Application for Planning Approval

DA2025/110

CHANGE OF USE (VETERINARY CENTRE) AND ASSOCIATED WORKS

174 Brighton Rd Veterinary Clinic

PAGE	NORTH
A09	
DRAWING	
PROPOSED SIGNAGE

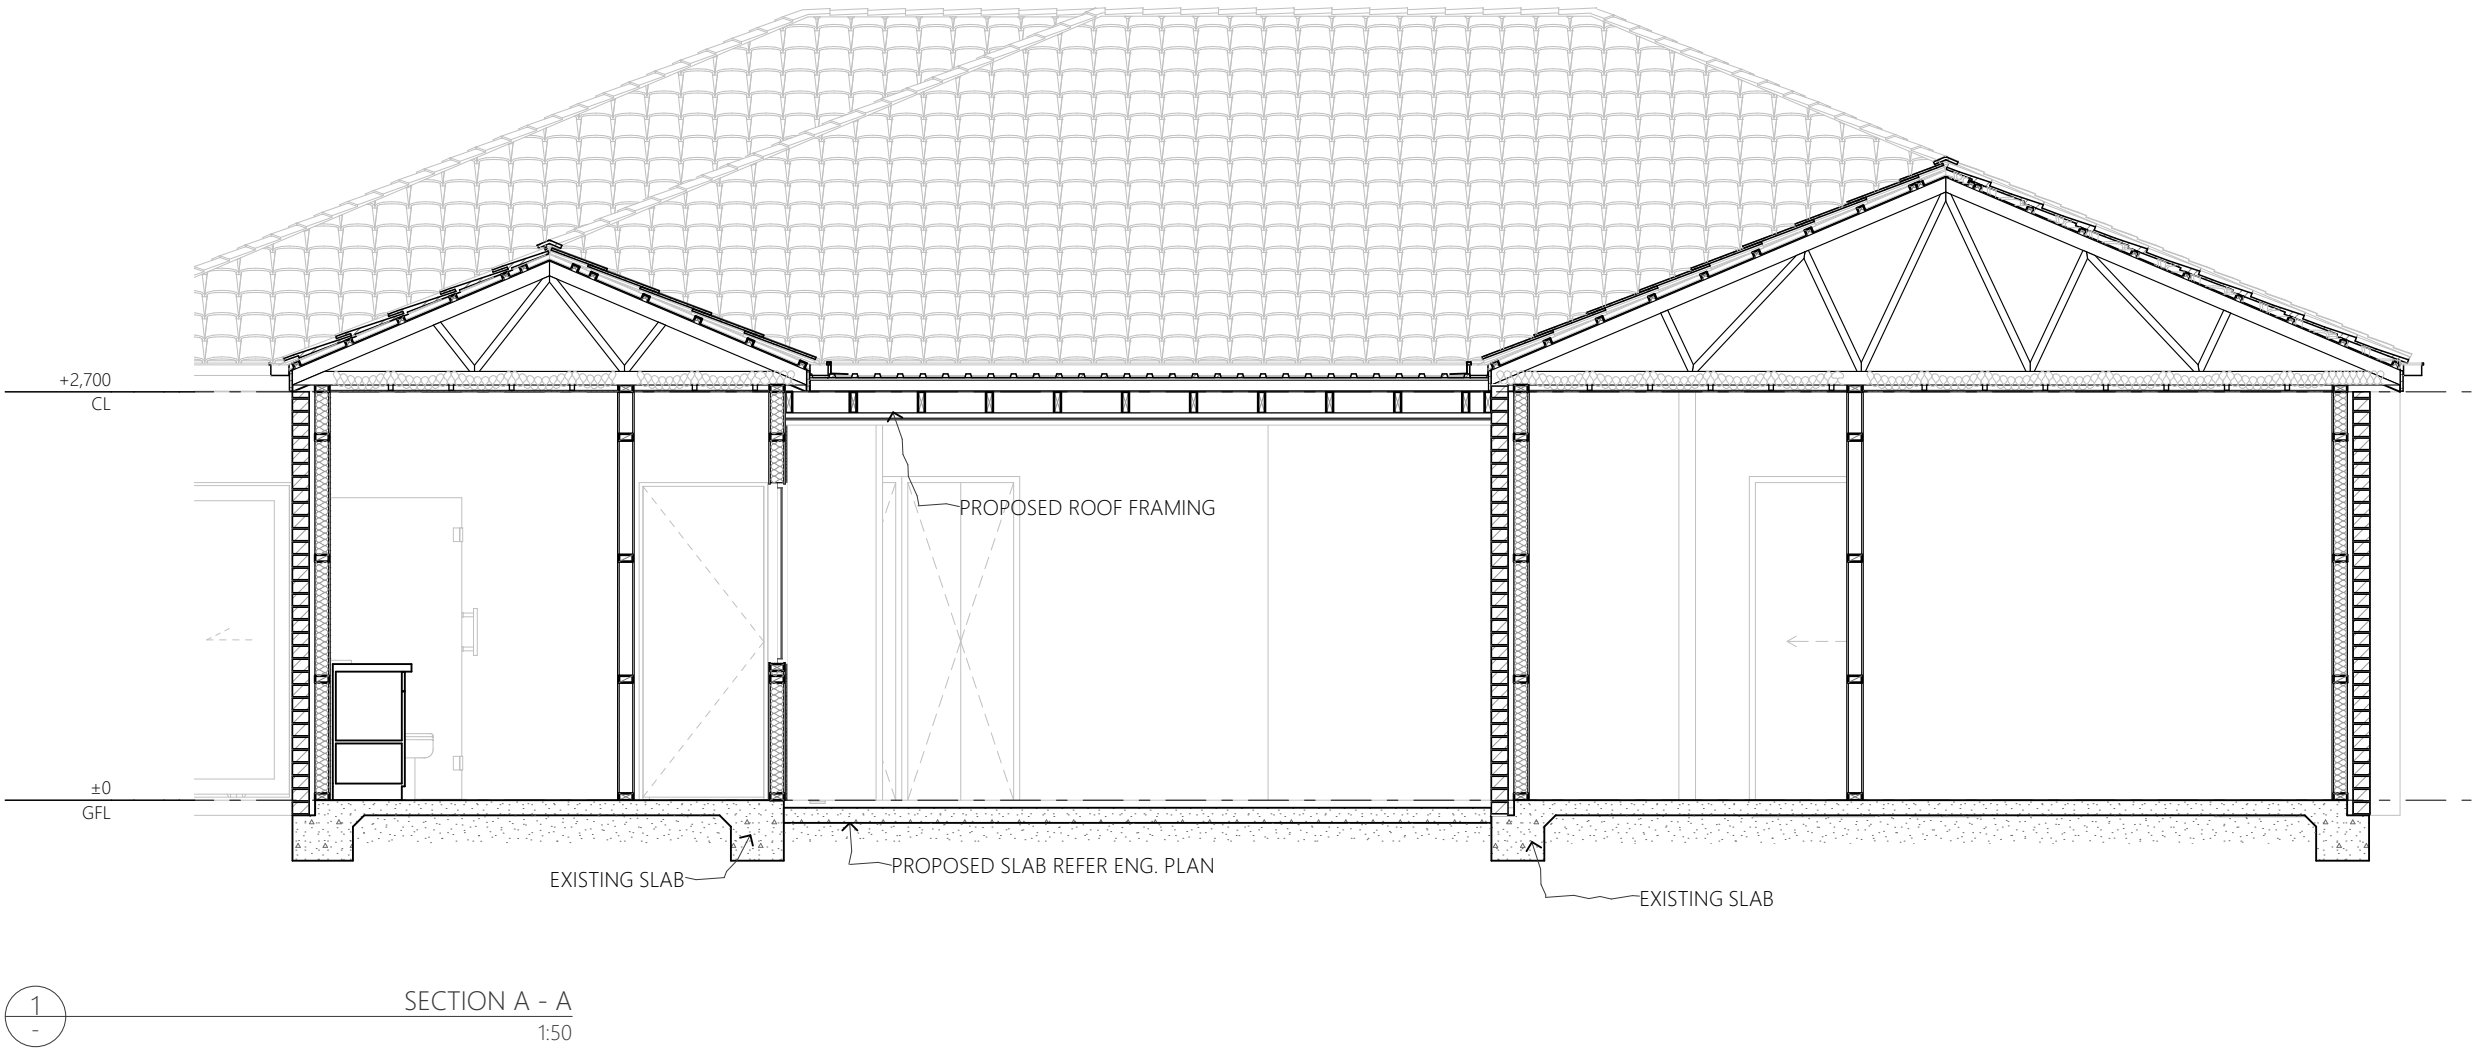
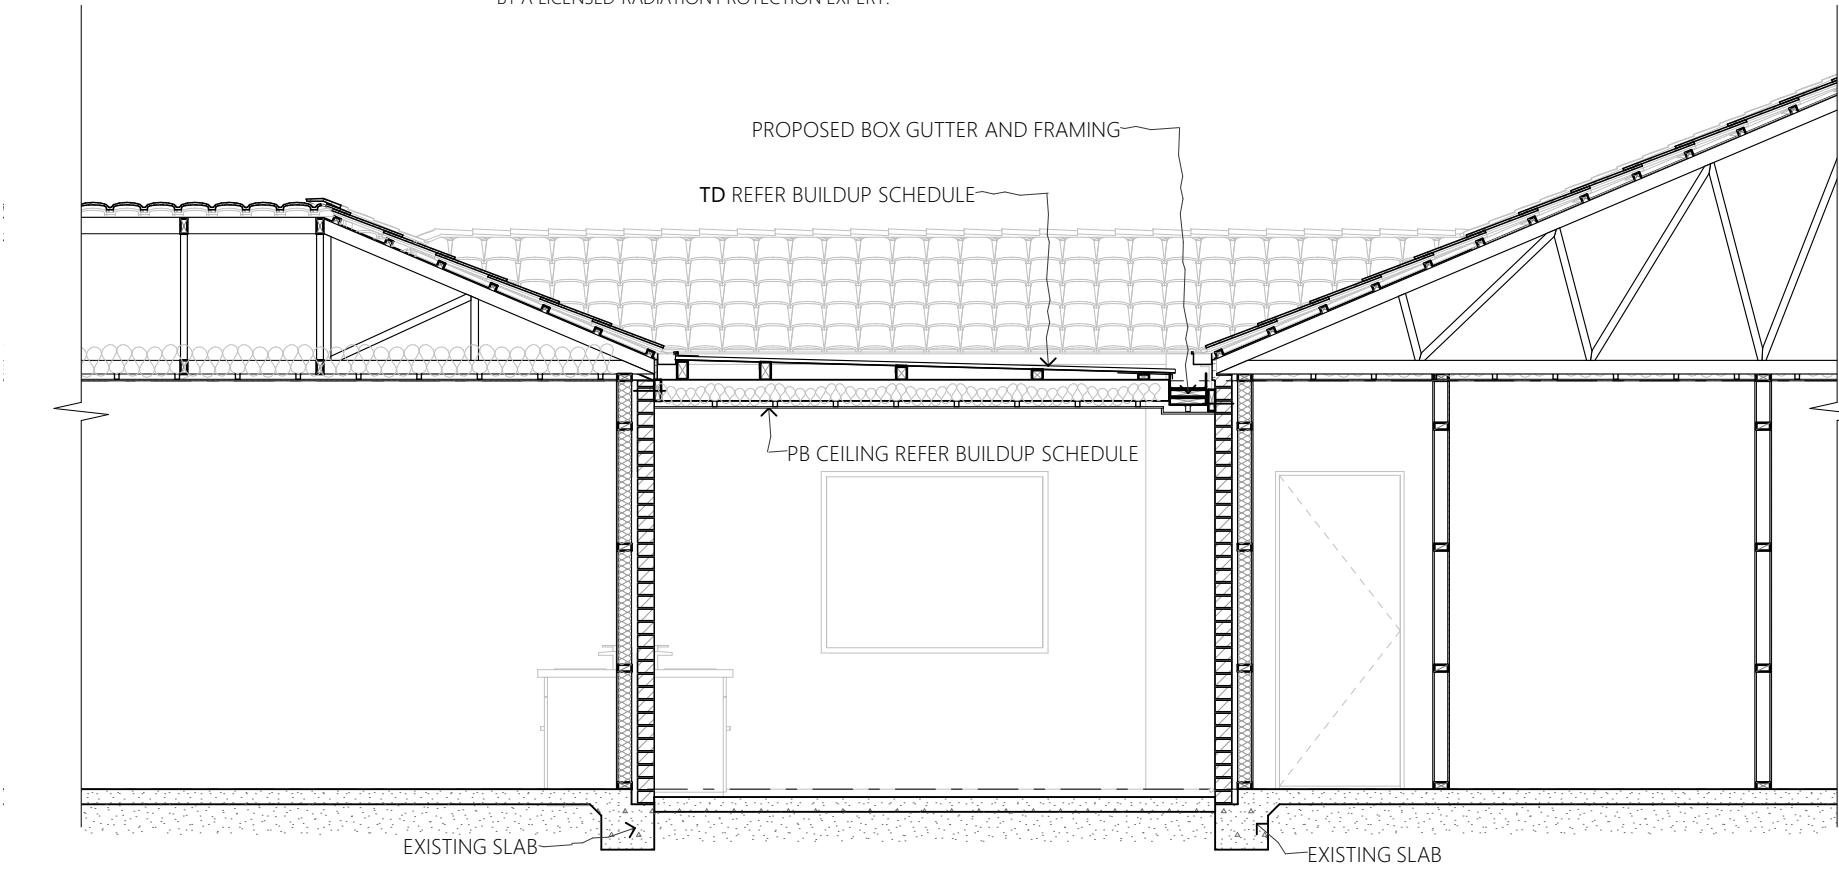
4. Please confirm whether any new signage is proposed to be installed for the business.

4. Please confirm whether any new signage is proposed to be installed for the business.

I have been advised there is proposed signage that has been submitted to council on a separate application. I have added the signage design on page A09.

Further information regarding proposed signage has been added to the updated signage drawings (A09) including dimensions and location. No signage is proposed to be illuminated.
